2015 Michigan Residential Code Errors and Conflicts

The following are errors and conflicts that have been identified at this point. The Bureau of Construction Codes has reviewed these issues. The Director of Department of Licensing and Regulatory Affairs has delegated the authority to make, and has approved, the following determinations which are binding on all enforcing agencies.

FIGURE R507.2.1(2)
PLACEMENT OF LAG SCREWS AND BOLTS IN BAND JOISTS

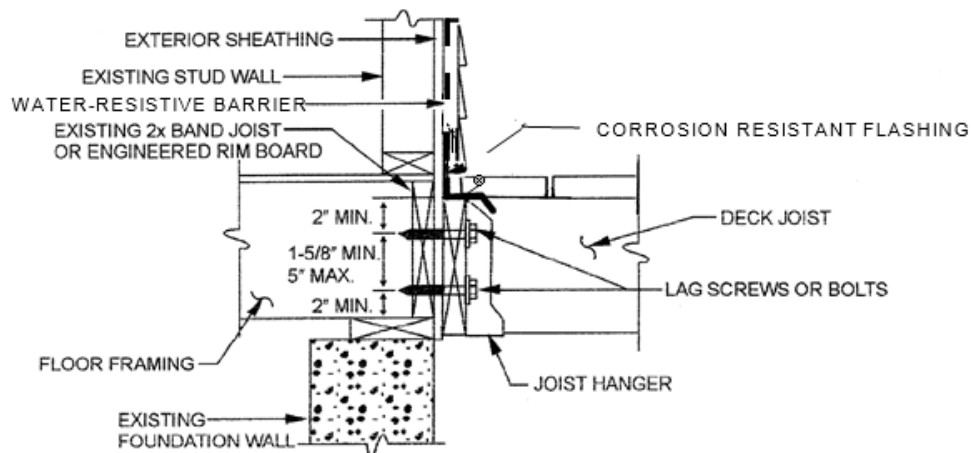
Figure R507.2.1(2) was obviously corrupted during the publication of the rules and was not noticed until it was published by the International Code Council. The figure that must be used by all enforcing agencies is now provided.
